ADDENDUM NO. 2

Reference: Northern Utah County Campus – Mountainland ATC
Utah College of Applied Technology – Lehi, Utah
DFCM Project No. 07039260

Addendum No. 2

Project:	Northern Utah County Building	Date:	17 August 2009
Address:	Thanksgiving Point	Project No.:	DFCM 07039260 / HFSA 0813.01
City, State:	Lehi, Utah	Agency:	Mountainland Applied Technology College

17 AUG 09
ADDENDUM #2
L1.1A

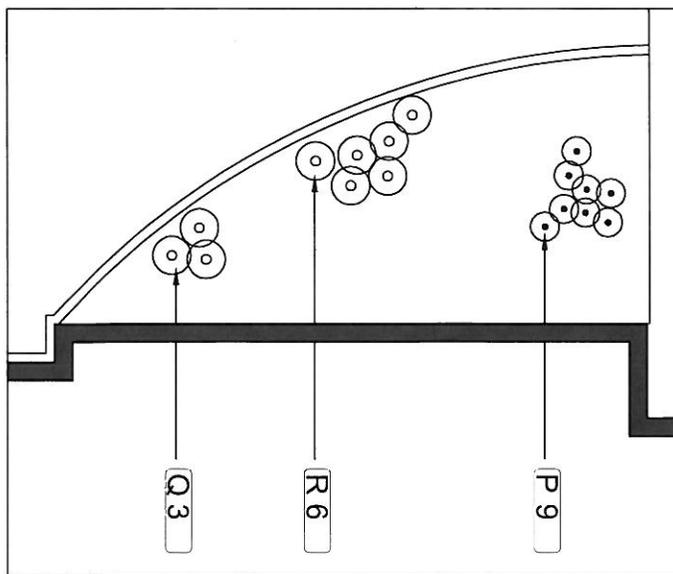
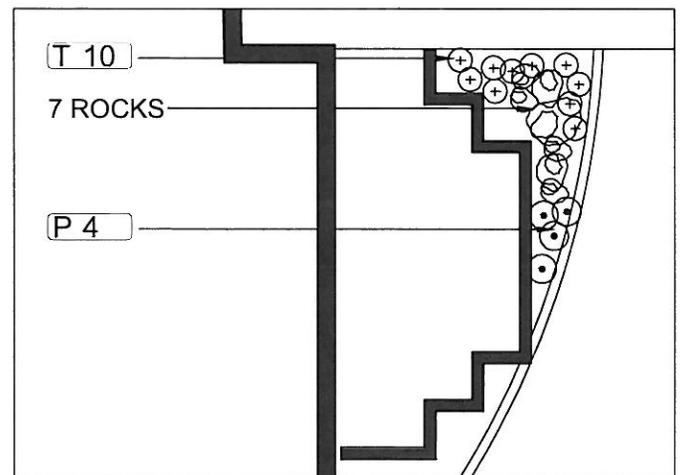
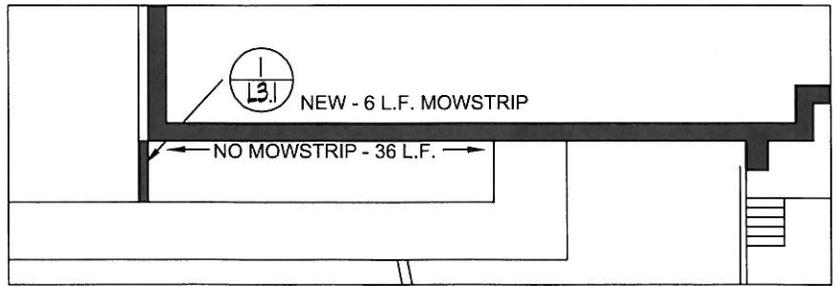
NEW MOWSTRIP
SCALE: 1" = 20'

CONCRETE JOINT & TIE ELEV. DETAIL

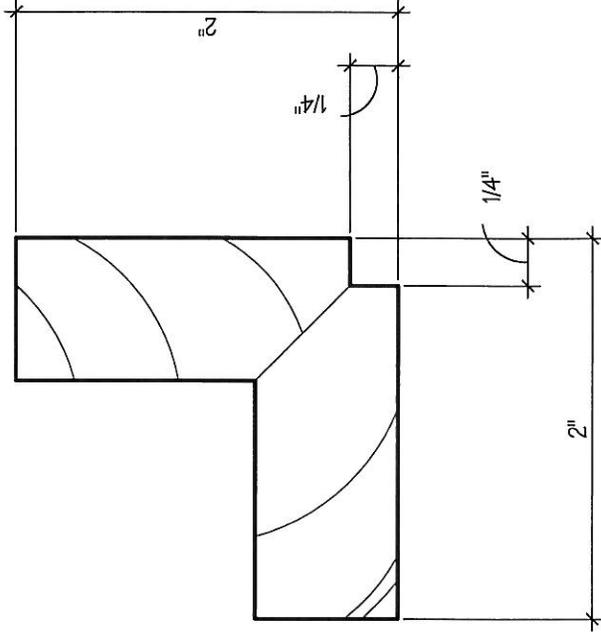
2-84	All Plan Sheets	Replace the 'FINISH SCHEDULE' with the attached revised 'FINISH SCHEDULE'.
2-85	All Plan Sheets	Add the attached 'ROOF DRAIN CHASE SCHEDULE'.
2-86	Clarification	Add the attached detail 'D1 - CONCRETE JOINT & TIE ELEV. DETAIL'.
2-87	Clarification	Add the attached detail 'E1 - TERRAZZO PATTERN DETAIL'.
2-88	Clarification	Add the attached detail 'B2 - FIRE PROTECTION @ SHAFT BEAMS'.
2-89	Clarification	Add the attached detail 'D3 - STAIR DETAIL'.
2-90	Clarification	Add the attached detail 'E3 - STAIR DETAIL'.
2-91	Clarification	Add the attached detail 'D1 - SLIDING GLASS DOOR DETAIL JAMB'.
2-92	Clarification	Add the attached detail 'E1 - SLIDING GLASS DOOR DETAIL HEAD'.
2-93	AS102	Detail A2: Add the following note: 'PROVIDE 28 ADDITIONAL SIGNS (IN ADDITION TO THOSE REQUIRED FOR ADA), 14 WILL HAVE TEXT RESERVING STALLS FOR "LOW-EMITTING AND FUEL EFFICIENT VEHICLES" AND 14 WILL HAVE TEXT RESERVING STALLS FOR "CAR / VAN POOLS".'
